PREVOST

**SAFETY
RECALL**

SR23-07

| SUBJECT: | Hazard Warning Lights Synchronization | | |

3. Reconnect the faulty wire.

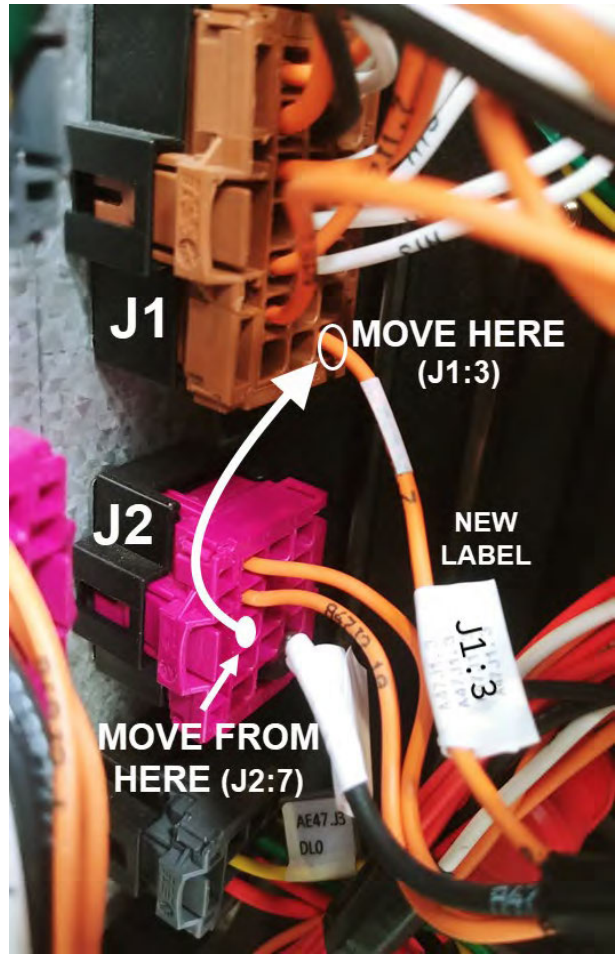
- Locate wire **J2:7** (J2 middle connector)
- Disconnect J2 connector (see note for correct removal procedure)
- Remove the **J2:7** wire using extractor tool **568103** (see note for correct removal procedure).
- Put a label on the wire indicating that it will now be named **J1:3**.
- Reconnect the wire into J1:3 cavity of the J1 (top) connector.
- Reconnect the J2 connector.
